# 2401 INTER LIGHTING PLAN

A PORTION OF THE SW 1/4 OF SECTION 26, TOWNSHIP 20 N, RANGE 4 E, W.M. PIERCE COUNTY, WA

2401 INTER AVE SE  
PUYALLUP, WA 98372

**2401 INTER LIGHTING PLAN**

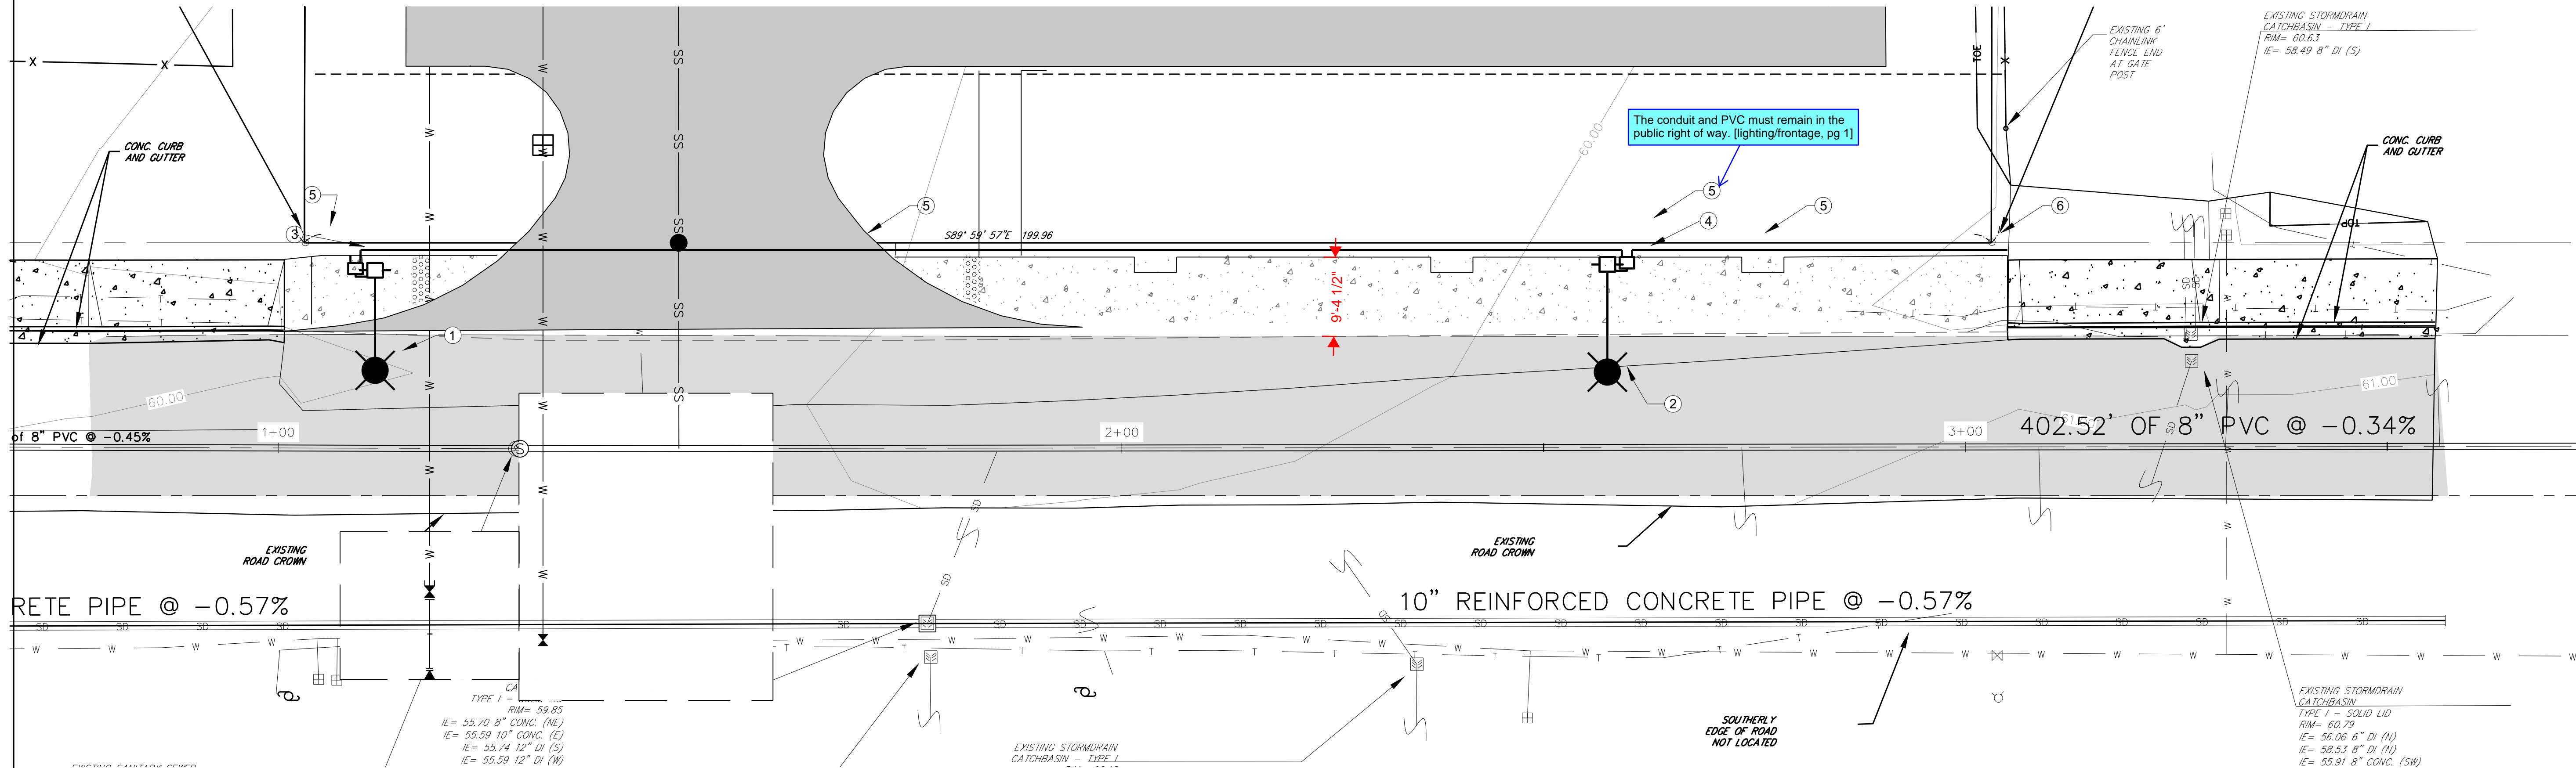
Indicate that this is also the Frontage Plan. [lighting/frontage plan]

Clearly shows the edge of the property. [lighting and frontage plan, pg 1]

Show the edge of the right of way [lighting/frontage plan, pg 1]

Show the following required frontage improvements: 8' wide sidewalk (remove street trees), half-street paving and curb and gutter along the entire frontage. [lighting/frontage plan, pg 1]

The conduit and PVC must remain in the public right of way. [lighting/frontage, pg 1]

Provide a legend for the different proposed line and hatch types. [lighting and frontage plan, pg 1]
